Office of Environmental Sustainability,
Environmental Protection Agency,
P.O. Box 3000,
Johnstown Castle Estate,
Co. Wexford

Re: Longfield Poultry Ltd. P1150-01

I refer to previous Agency correspondence of 23rd May last. Please find detailed below the response to the issues raised.

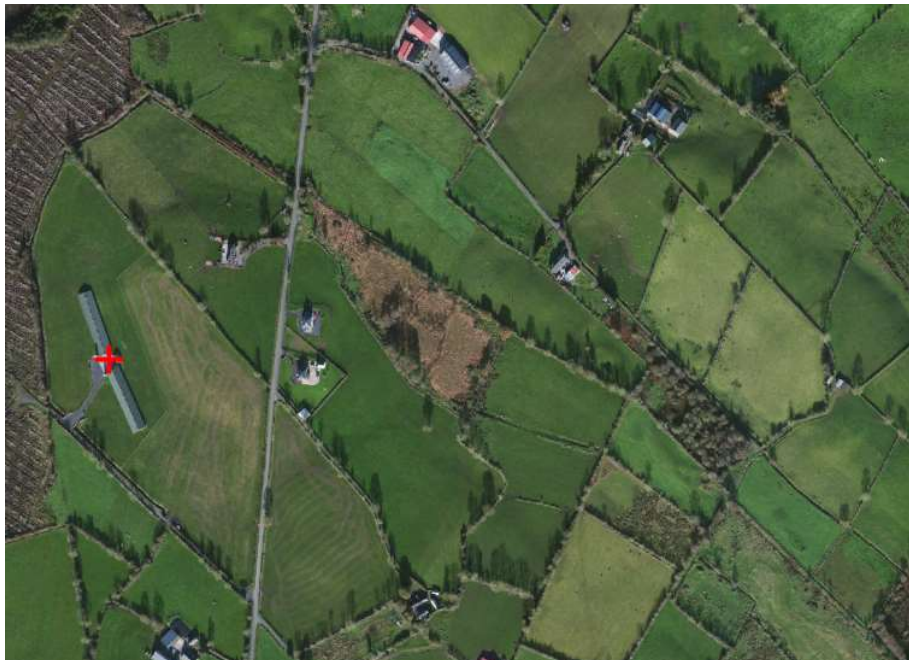
- 1. The grid reference provided for the site appears to be incorrect. Supply the correct grid reference for the site.**

Please refer to updated co-ordinates below.

ING (EPSG 29902) Easting: 263890.48

ING (EPSG 29902) Northing: 286408.61

ITM (EPSG 2157) Easting: 663827.90

ITM (EPSG 2157) Northing: 786423.97
